From:
To: [DCAdmin](#); [RichardA Gilbert](#)
Subject: Submission to the public consultation for Planning Application ref 2021/94552 - Impact on neighbouring Tanner Wood and adjacent related habitats
Date: 08 March 2022 19:19:13
Attachments: [Development proposal effects on Tanner Wood and wildlife habitats 07_03_22.pdf](#)
Importance: High

Effects on Tanner Wood and Wildlife Habitats

SUMMARY

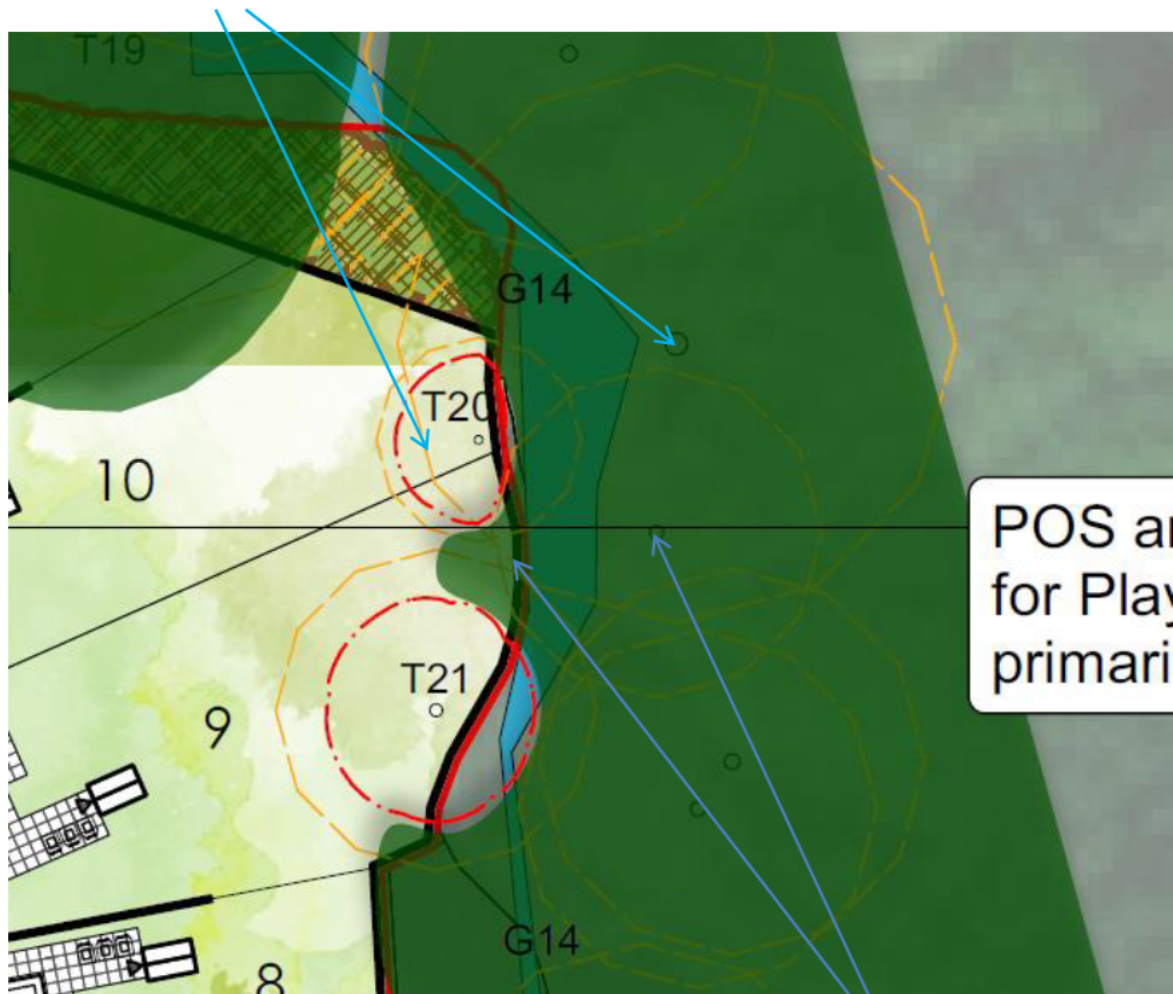
This advice seems to have been largely ignored by the proposed development layout, as can be seen in this table of the RPA threats for each of the affected Tanner Wood trees:

Tree	Location	Threats to Tree RPA's
T19 Oak	Adjacent to Plots 10, 11, 12	Ground level increased by 3-5 metres, New retaining wall 3-5 metres high. Underneath garden of plots 10, 11, & 12.
T18 Oak	Adjacent to Plot 12	Ground level increased by 5 metres, New retaining wall 5 metres high. Underneath retaining wall.
T17 Oak	Adjacent to Plot 13	Ground level increased by 5.5 metres, Foundations of new retaining wall 5.5 metres high at edge of RPA.
G14 Oak 'A'	Rear of Plot 9	Ground level increased by 3 metres, New retaining wall 3 metres high. Underneath garden of plot 9.
G14 Oak 'B'	Rear of Plot 10	Ground level increased by 3 metres, New retaining wall 3 metres high. Underneath garden of plot 9/10.
T22 Sycamore	Adjacent to Plot 7	Ground level increased by 3 metres, New retaining wall 3 metres high. Underneath retaining wall.
T23 Hawthorn	Adjacent to Plot 7	Ground level increased by 3 metres, New retaining wall 3 metres high. Underneath retaining wall.

T25 Horse Chestnut	Opposite Plot 1	Ground level increased by 1.8 metres, New retaining wall 1.8 metres high. Underneath retaining wall, and corner of new road.
G14 Oak 'C'	Rear of Plot 17	New 'Native Shrub spot planting' area (control of digging needed)
T16 Oak	Rear of Plot 15	New 'Native Shrub spot planting' area
G24	Rear of Plots 5, 6	Adjacent Ground level increase of 2 metres, and building of retaining wall 2 metres high

To avoid these significant issues, the layout will need to be reviewed and amended, moving the increased ground levels, and retaining wall, away from the RPA's of all of the trees in the table above. This will affect Plots from 7 to 13.

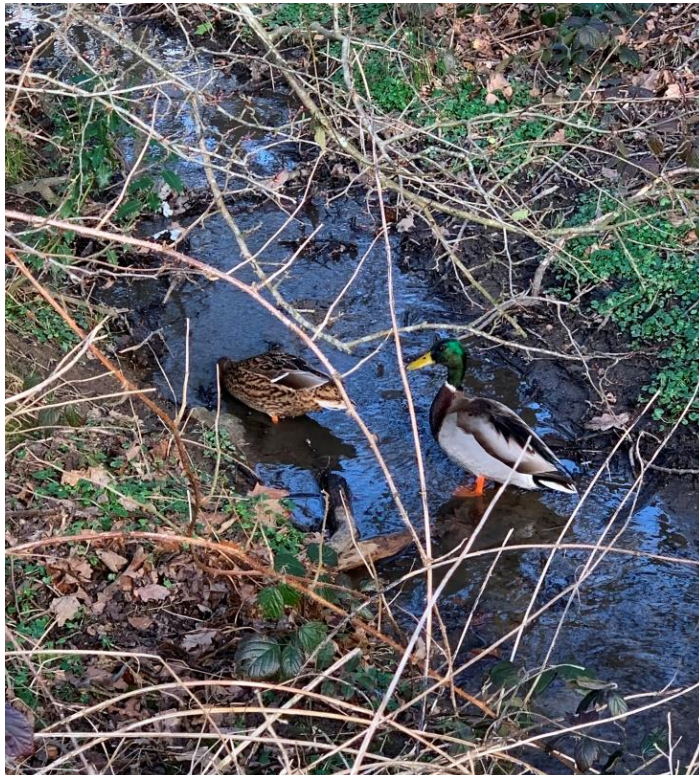
For example, BS5837, Page 8 – Table 1 shows how trees may be categorised both as individuals, and for their Landscape value within a group or woodland. There is also a subcategory for Cultural value. Thus subcategories within Retention value A, are A1, A2, and A3.

AWA consultants have not followed the Standard to this level of detail unfortunately, and had they done so then T19 and T13 for example may have been classified as A2, and therefore A, for being a natural part of the overall woodland.

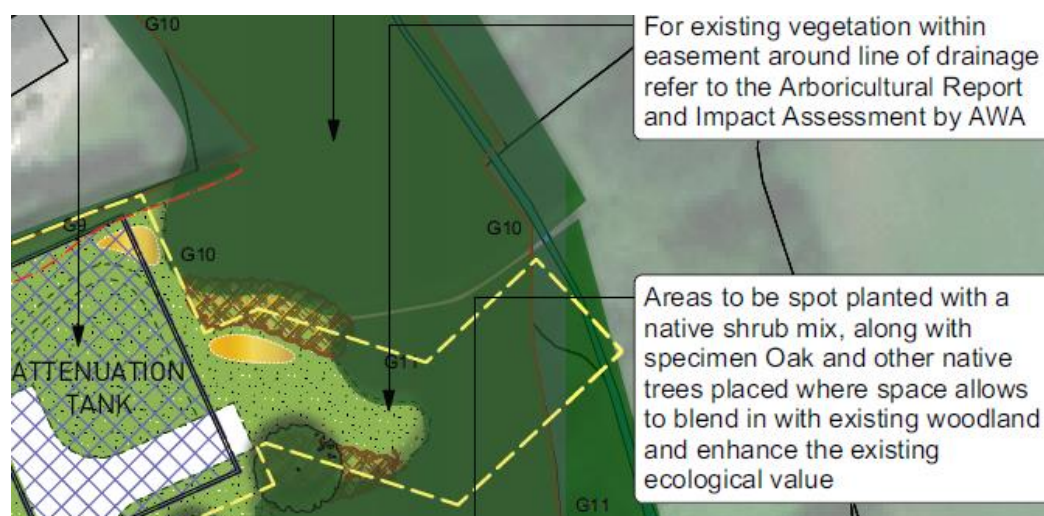
The separation distance from the proposed retaining wall and garden fencing to the watercourse is in some cases less than 1m, and at most under 6m.

It is alongside this watercourse that native woodland plants such as Wood Sorrell, and Lesser Celandine are currently seen, therefore protection of this habitat is a priority.

The risks to the watercourse appear most significant during the construction phase, as the proximity of the retaining wall position to the watercourse, combined with the need to install Tree protection fencing and contaminant prevention silt fencing, whilst allowing space to excavate wall foundations, make it seem inevitable that the watercourse will be contaminated and the banks damaged. Appendix 1 shows an illustration of this.

From the landscape perspective a buffer zone should be allowed for in this part of the development, to protect the watercourse, and flora, from human proximity, and the potential for the unintentional release and spread of invasive plant species from private gardens.

Appendix 1.

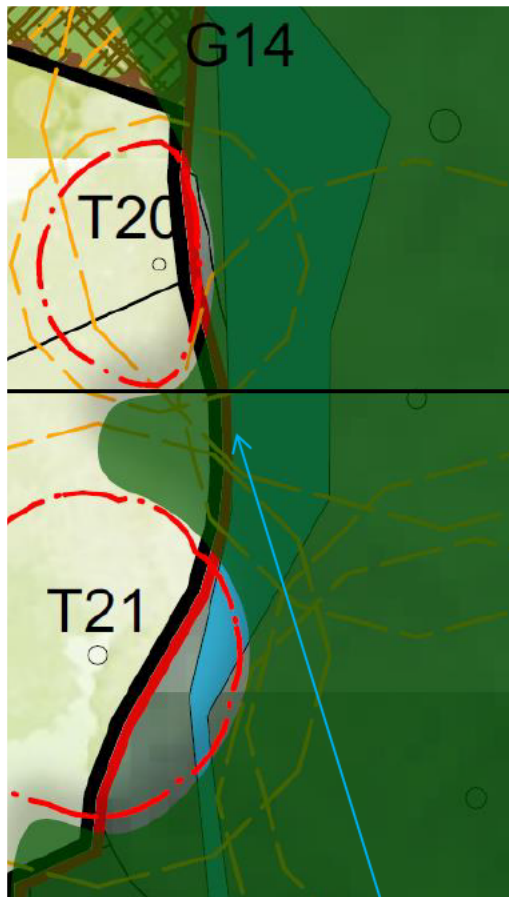
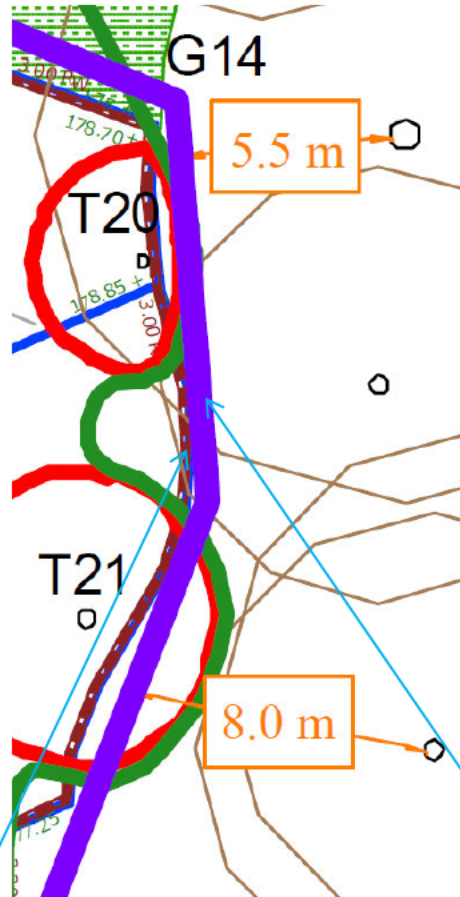
These extracts are from the Site Layout drawing, and the Arboriculture Method Statement:

Watercourse – Hayley Well Beck

Retaining wall

Tree protection fencing
